ARCHITECTURAL REVIEW BOARD MEETING

NOVEMBER 14, 2023 IN THE CITY COUNCIL CONFERENCE ROOM AT 5:00 PM

PLANNING AND ZONING COMMISSION CASE MEMO

TO: Planning and Zoning Commission
DATE: November 14, 2023
APPLICANT: Salvador Salcedo
CASE NUMBER: SP2023-032; *Site Plan for 855 Whitmore Drive*

FRONT ELEVATION

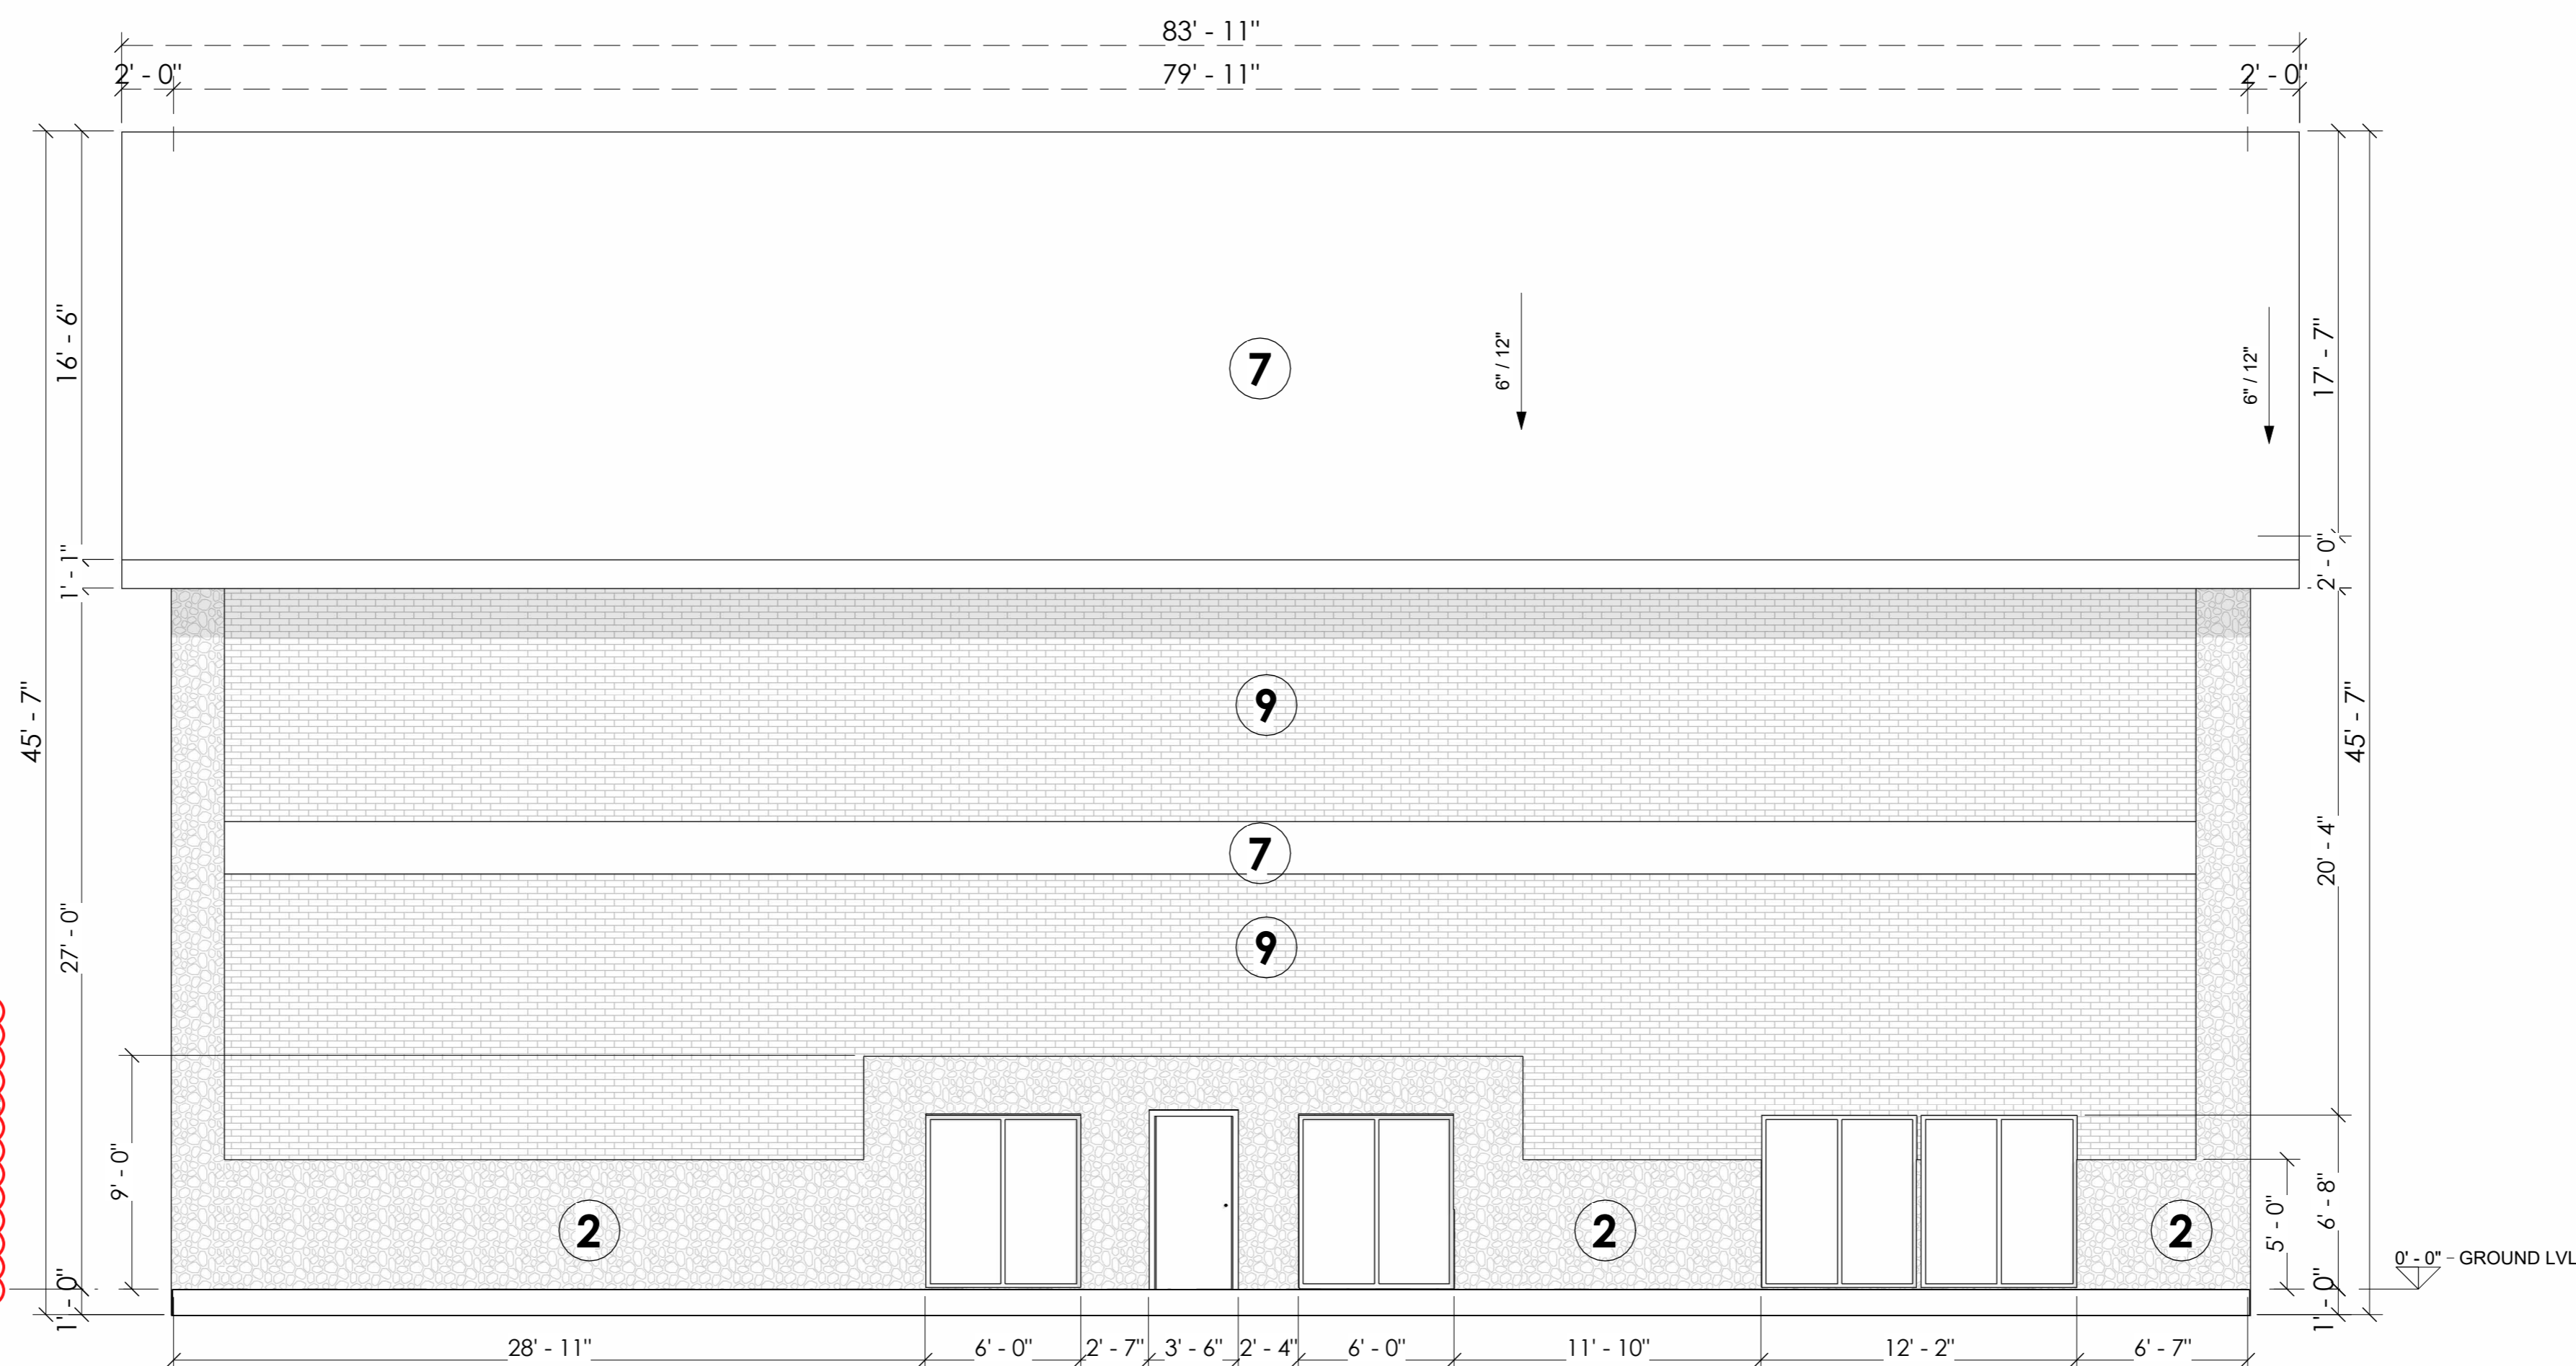
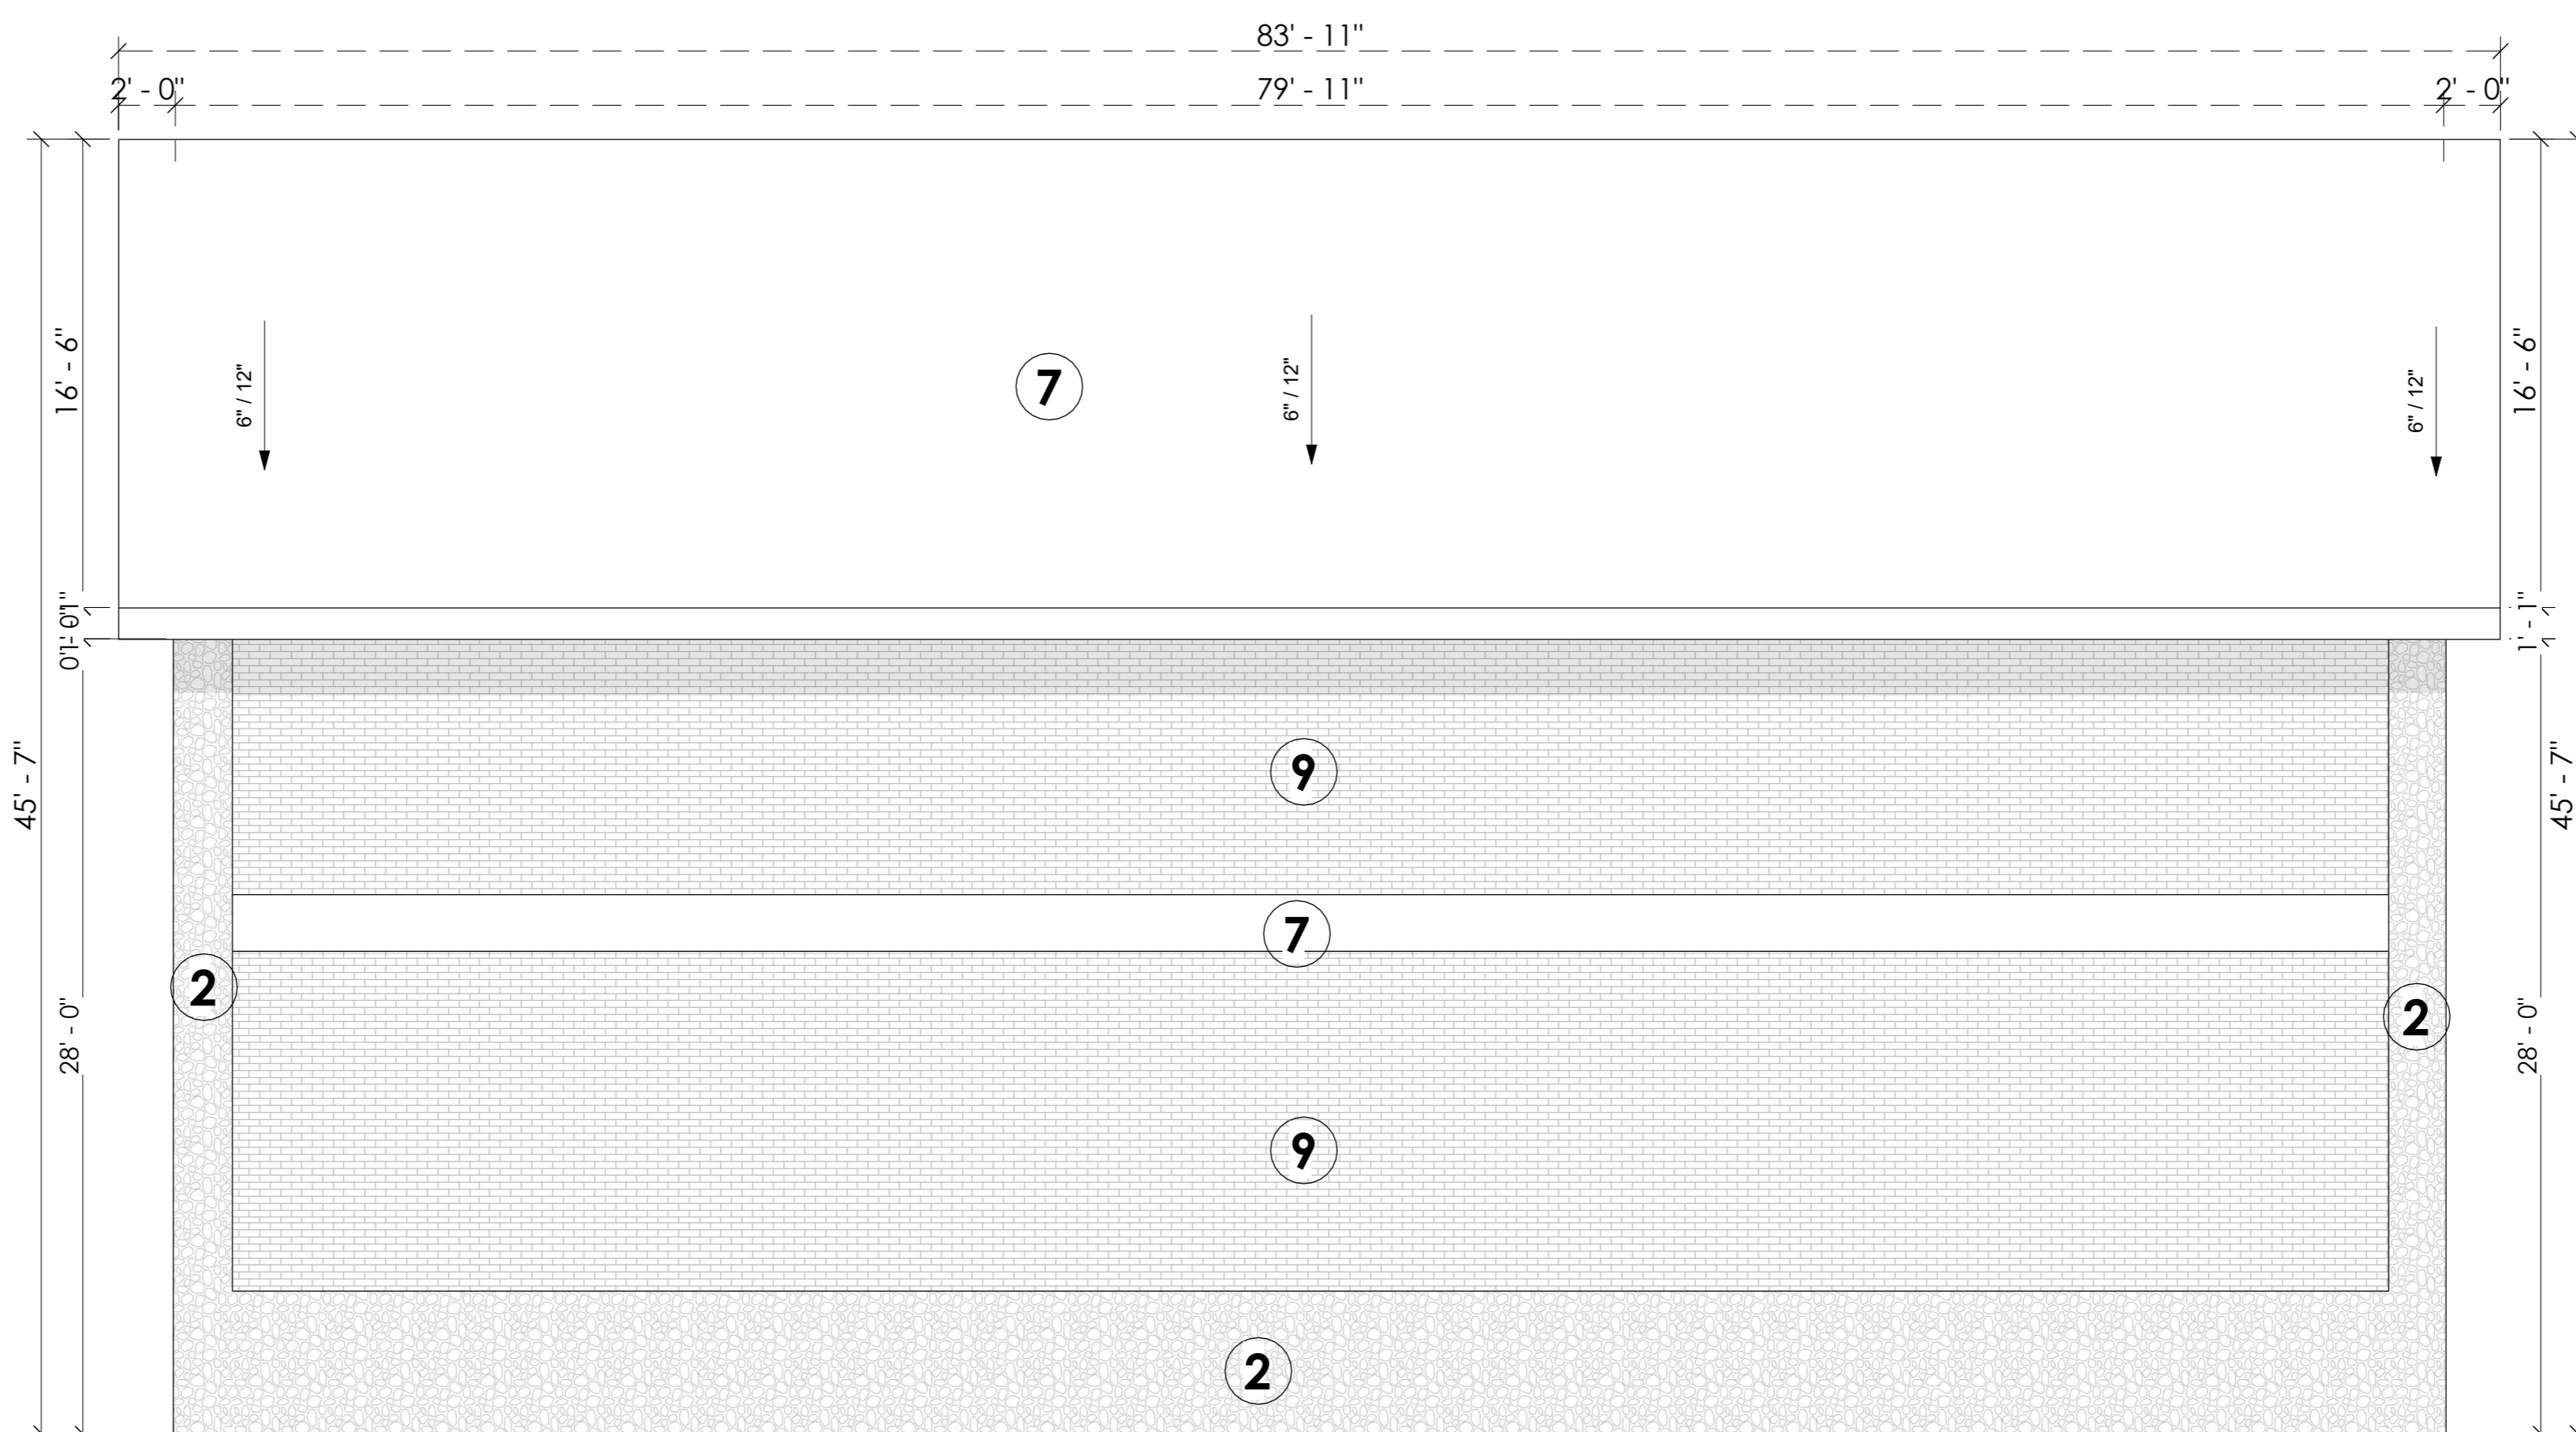
- (a) Primary and Secondary Building Facades. According to Subsection 05.01 (C), *General Industrial District Standards*, of Article 05, *District Development Standards*, of the Unified Development Code (UDC), for primary building facades a wall projection should extend 25.00% of the wall height above and away from the wall, and for secondary building facades a wall projection should extend 15.00% of the wall height above and away from the wall. In this case, the proposed building does not meet the projection requirements. This will require an exception from the Planning and Zoning Commission.

REV. NO.	DATE	COMMENTS
2	09/30/2023	a) INCLINACIÓN DEL TECHO CORREGIDA DE 3:12 A 6:12 b) THE WALL LENGTH REQUIREMENTS FOR THE NORTH, EAST, WEST AND SOUTH FACADES WERE CORRECTED c) THE MATERIALS AND PERCENTAGES OF MATERIALS WERE CORRECTED ACCORDING TO THE ESTABLISHED REQUIREMENTS
3	11/06/2023	A) TABLE OF AREAS AND PERCENTAGE OF MATERIALS WAS ADDED
